ADDENDUM #1

Date: May 22, 2017
Project #: 16054
Project: Binnerri Presbyterian Remodel

Delta #: 1
Reference: Bidding Clarifications
Sheets Affected:
Sheets Added:

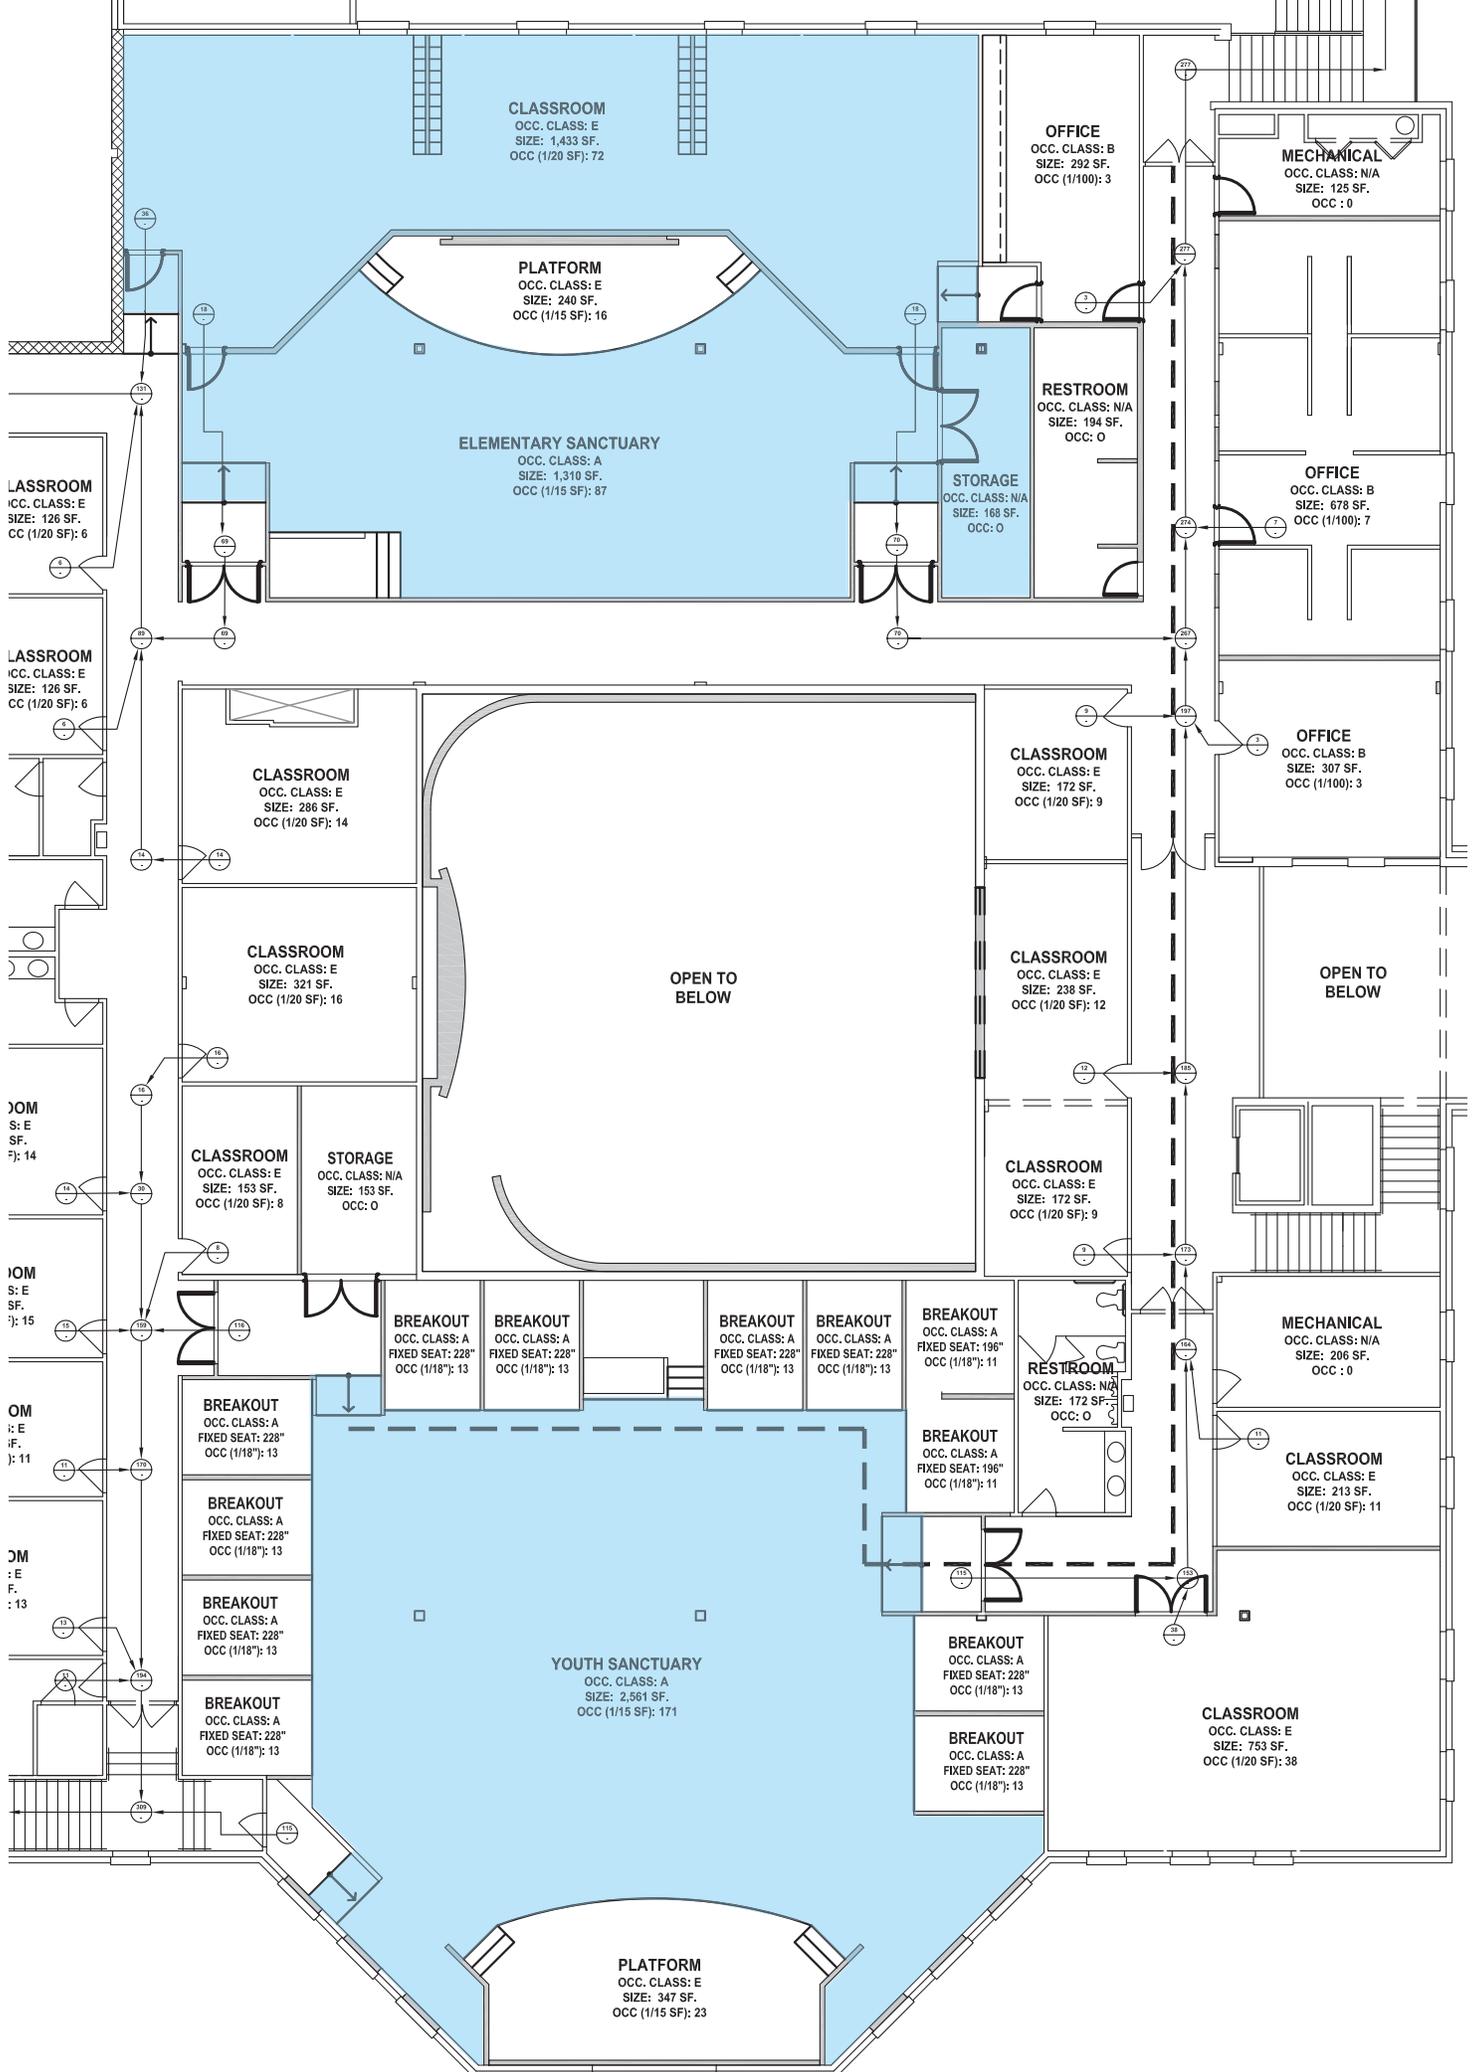
2. Answer: Yes, an AutoCAD base plan will be available for their use.
3. Question: Can you outline the area where the kinetic floor is specified?
3. Answer: Refer to the attachment included with this Addendum for scope of Kinetic Floor. The Kinetic underlayment is used in Youth Sanctuary 209 and Elementary Sanctuary 232.

CERBERUS
PYROTRONICS

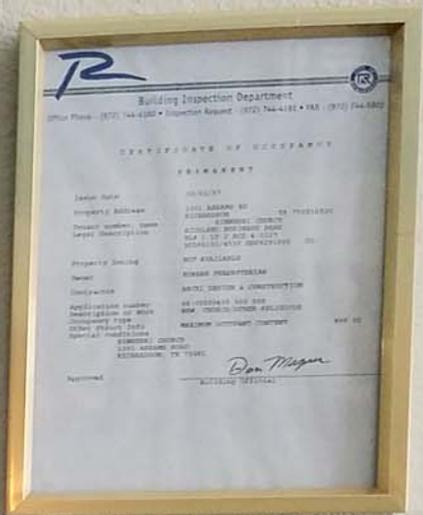
8. Question: What is the existing fire alarm system and do you know who the installer was?
8. Answer: Details regarding existing fire alarm system/installer are unknown at this time. Refer to attached photo for reference.
